PRODUCT/PROCESS CHANGE NOTICE (PCN)

PCN #: L-0607-01R1	DATE: 6-Oct-06	MEANS OF DISTINGUISHING CHANGED DEVICES:
Product Affected: Please see the attached list of the affected products shipped in tape and reel, and in tubes		☐ Product Mark
Date Effective: 6-Oct-06		☐ Back Mark Lot shipments will have Level 1
		☒ Date Code Moisture Sensitive Label, and with
		☐ Other date code starting "0630".

PCN Type: Change in Moisture Sensitivity Level

From: MSL 3 Moisture Sensitive Label

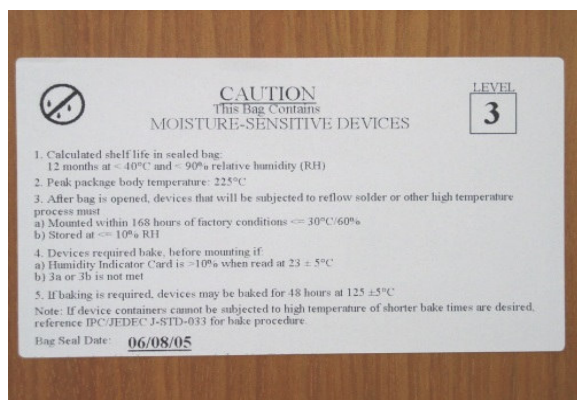
The affected products will be shipped without dry pack and labelled as MSL 1 according the JEDEC J-STD-033. There is no change to the assembly material set and the peak reflow temperature. Please refer below for the examples of moisture sensitive labels.

To: MSL 1 Non-Moisture Label

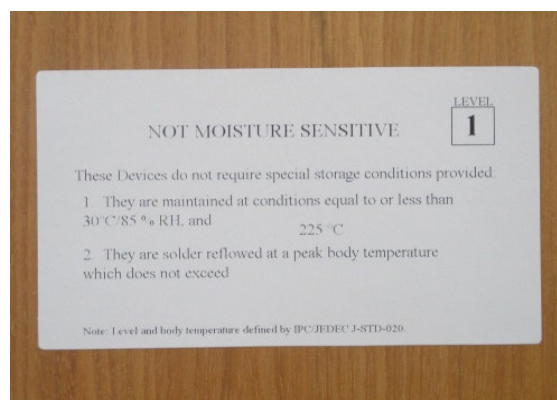
Note: There is no change to the peak reflow temperature of the affected products.
